Addendum to the Final Subsequent Environmental Impact Report (State Clearinghouse No. 2001051092) Approved August 23, 2010

Seawater Desalination Project at Huntington Beach:
Outfall Modifications—Modifications to the Multiport
Diffuser Design

Prepared by:
California Regional Water Quality Control Board, Santa Ana Region
3737 Main Street, Suite 500
Riverside, CA 92501-3339
July 2020

Figure 1. 2017 duckbill diffuser designs reproduced from 2017 FSEIR.

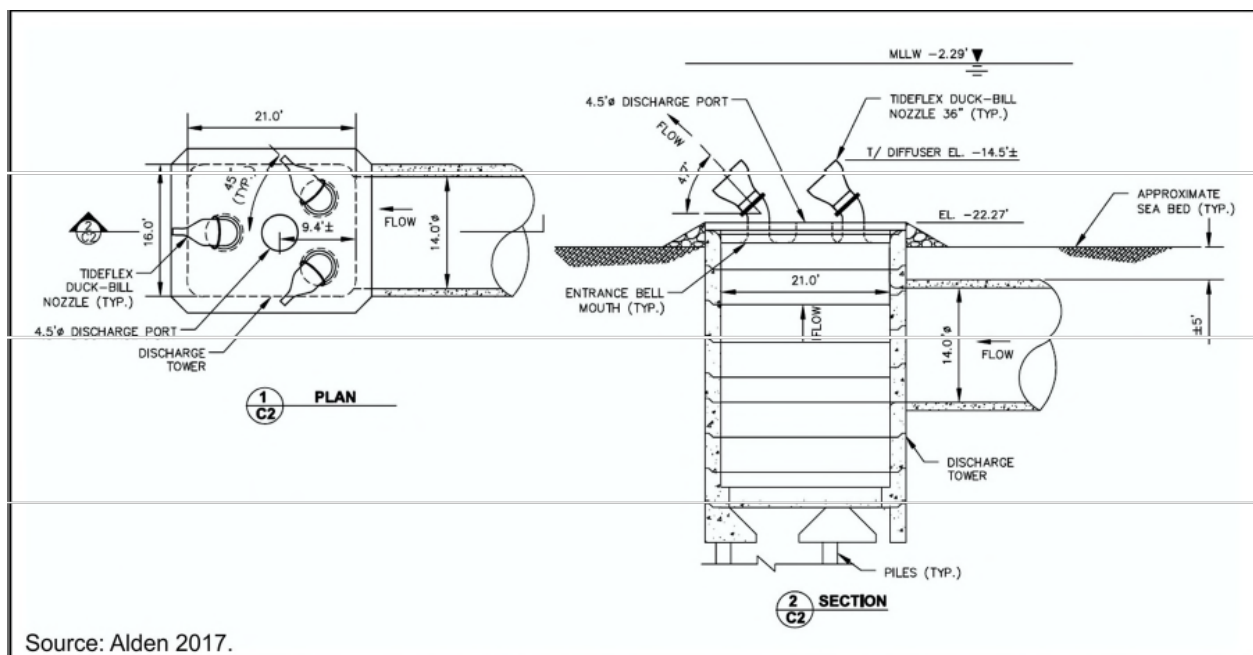
As part of the Lease Modification Project, Poseidon Water proposed to install a multiport diffuser with three 36-inch diameter duckbill valves and one 54-inch diameter central port on top of the existing HBGS discharge tower, which would be lowered to maintain the existing tower height (Figure 1).

Figure 2. Previously anticipated benthic footprint of the 2017 duckbill_diffuser design analyzed in 2017 FSEIR. Figure is reproduced from 2017 FSEIR.

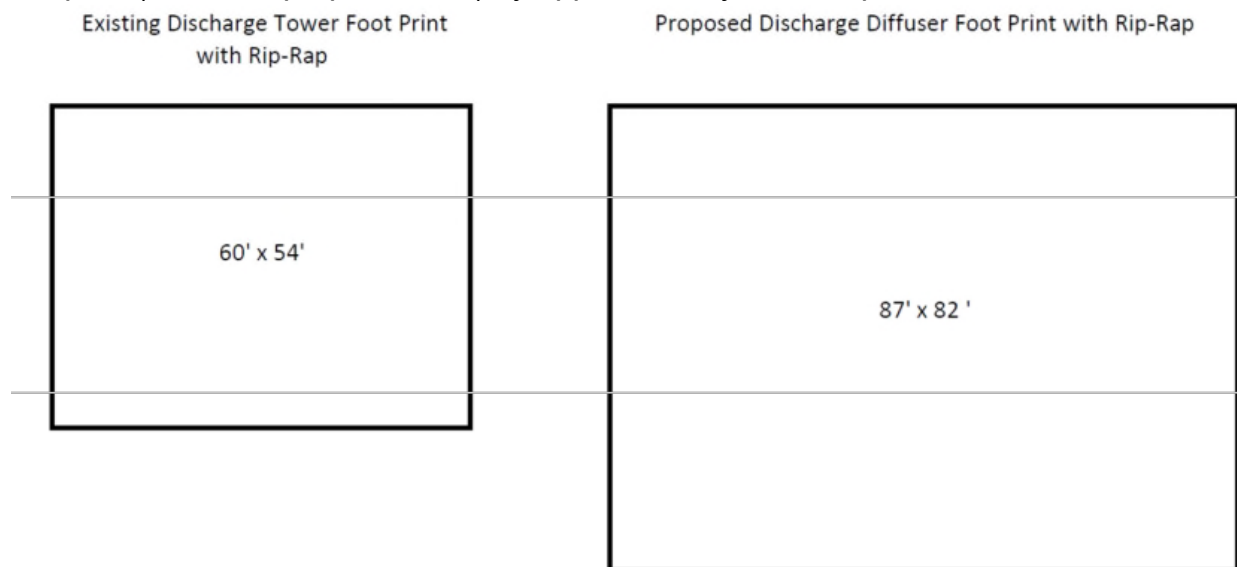
The 2017 duckbill diffuser would have occupied the same physical space as the

existing HBGS discharge tower; however, the riprap surrounding the discharge tower would have been side cast and reconfigured resulting in an increase of the total area footprint (with the riprap included) by approximately 4,000 square feet.

Figure 3. New linear diffuser design provided by Alden Labs on behalf of Poseidon Water (Attachment 1)

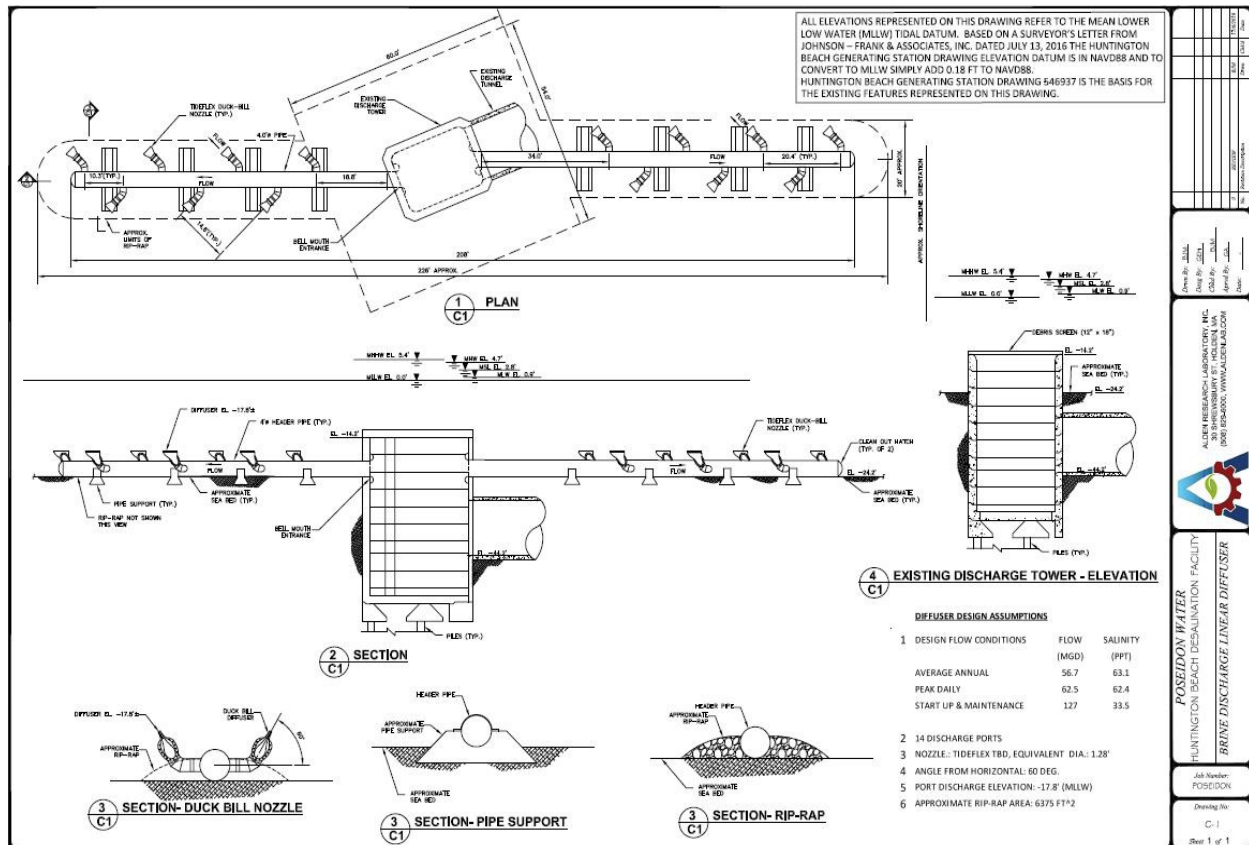
The modified diffuser design proposed by Poseidon Water would incorporate two 7-port linear diffuser sections connected to the seaward and shoreward sides of the existing discharge tower and would be oriented perpendicular to the shore to minimize wave loading forces on the diffuser. Each linear diffuser section would consist of a 4-foot diameter pipe header and each port would be equipped with a duckbill type check valve. The modified diffuser would be placed directly on the seabed on concrete pipe saddles that would secure the pipes.

Figure 4. Revised benthic footprint from modified diffuser design. On the left is Figure 2, reproduced from above, and on the right is the revised footprint from Attachment 1

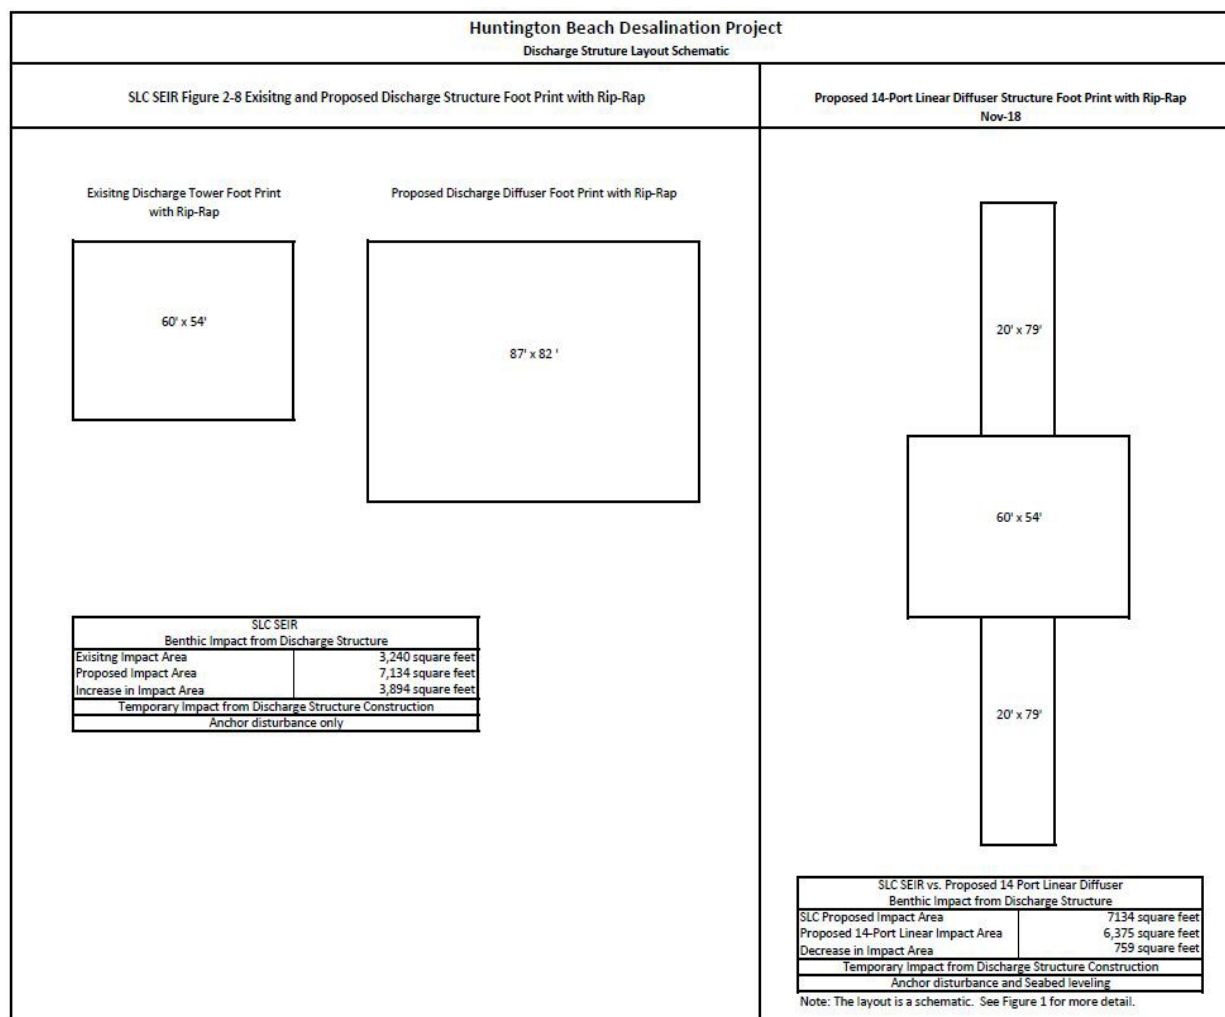
Riprap would be placed around the pipes and the existing discharge tower to avoid scour under the diffuser's structures. The existing discharge tower and the modified diffuser would be approximately 208 feet long, and the riprap area will increase the total length to approximately 226 feet. The modified diffuser riprap area would occupy an area of approximately 226 feet by 20 feet, including a portion of the existing discharge tower riprap area. This would decrease the diffuser footprint (including the protective riprap) from the approximately 7,134 square feet for the 2017 duckbill diffuser design analyzed in the 2017 FSEIR to approximately 6,375 square feet for the modified diffuser, existing discharge tower, and riprap area, for a total reduction of approximately 759 square feet. The new footprint would extend beyond the area identified in the 2017 FSEIR by approximately 65 feet, both seaward and shoreward, from the existing discharge tower.

Permanent benthic impacts will also be less than those identified in the 2017 FSEIR. The total area of the 2017 duckbill diffuser design was 7,134 square feet, whereas the total area for the modified diffuser design is 6,375 square feet, thus resulting in a benthic footprint that is 759 square feet smaller. (See Figure 4 above.) Therefore, construction, operation, and maintenance of the modified diffuser would not create a new significant impact nor cause a substantially more severe impact on marine biological resources than those analyzed in the 2017 FSEIR.

Figure 2. Modified 14-port linear diffuser design. Design is documented in Appendix BBBB-2 (November 27, 2018).

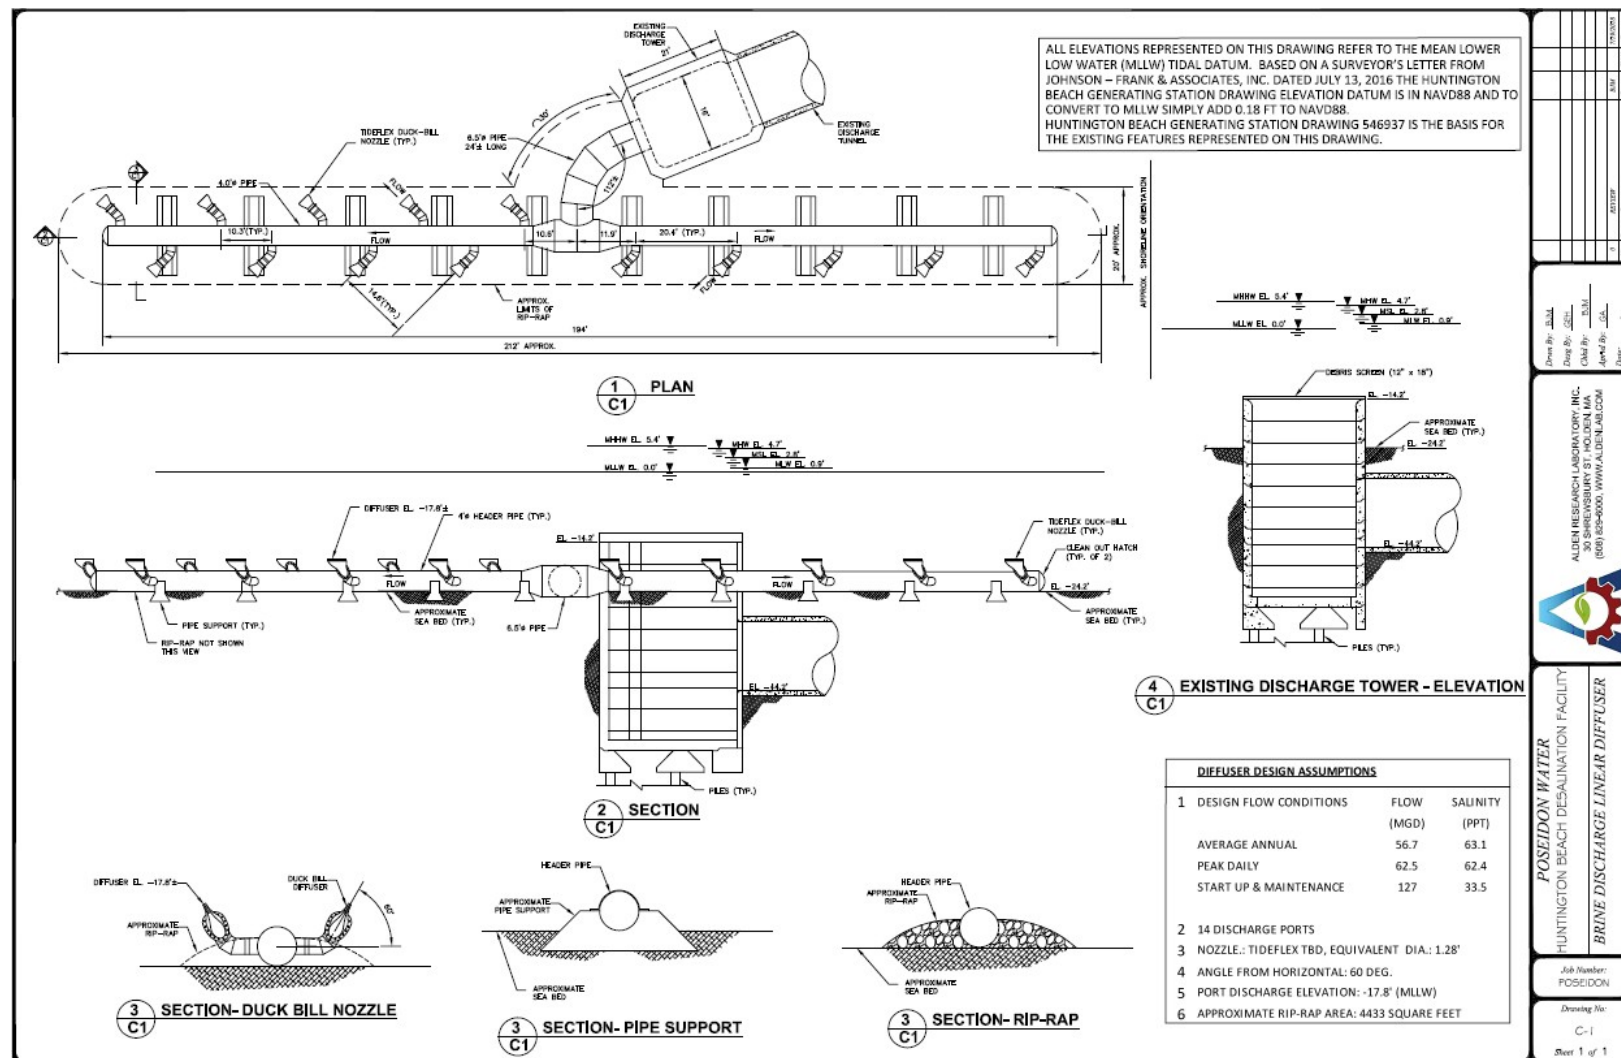
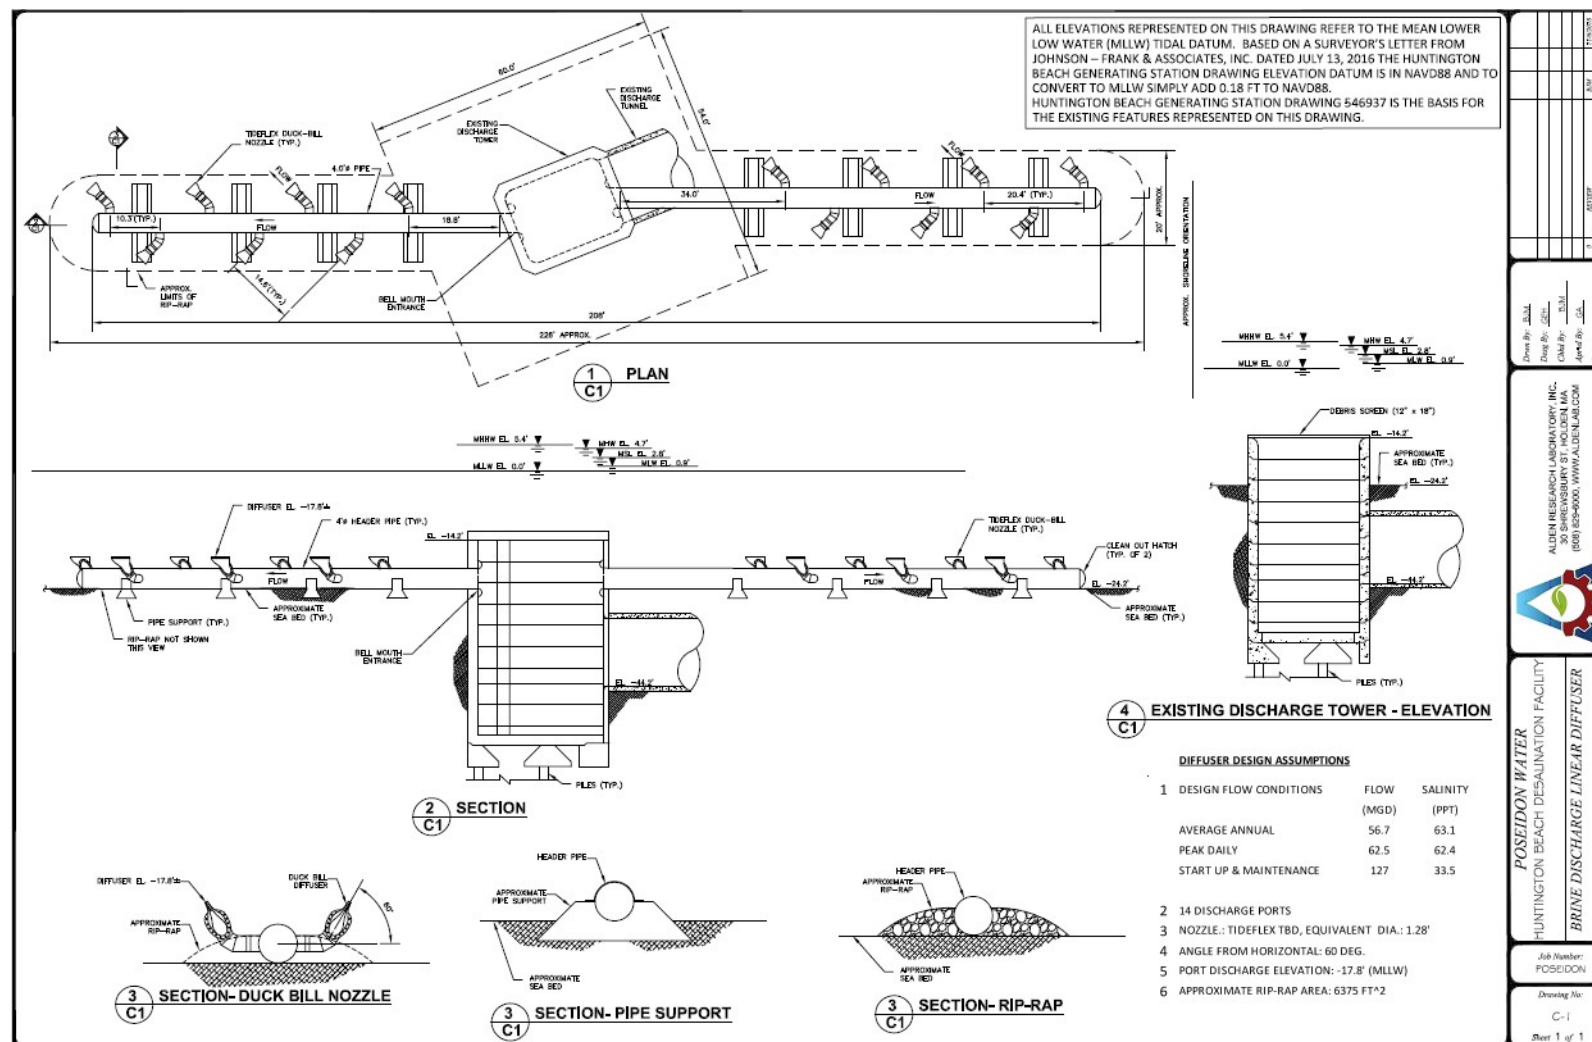
The initial 14-port linear diffuser design (Figure 1) was submitted on August 3, 2018 as part of Appendix BBBBBB in a report prepared by Alden Research Laboratory (Alden 2018). Appendix BBBBBB also included an environmental analysis report from Dudek (Dudek 2018a) which evaluated the initial 14-port linear diffuser design.

Table 1 provides a comparison of the design details for each 14-port linear diffuser alignment. The overall length of the diffuser and the length of the riprap associated with it have increased slightly; however, the total seabed area effected has not since the elbow needed to connect to the existing discharge tower is no longer included (see Figure 1 and Figure 2). Therefore, relative to the FSEIR, there are no additional benthic impacts associated with the modified alignment of the 14-port linear diffuser. Similarly, as reported in Appendix NNNNN, the brine mixing zone (BMZ) area is 1.09 acres. This compares favorably to the previous BMZ area of 0.64 acres. In addition, the size of the realigned diffuser's BMZ is consistent with the operational impacts evaluated in the FSEIR and still remains well within the OPA's 100-meter (328 foot) boundary. Therefore, operation of the realigned linear diffuser would not create a new significant impact to marine biology and would not cause a

The initial and modified 14-port linear diffuser alignments are depicted in Figure 1 and Figure 2, respectively.
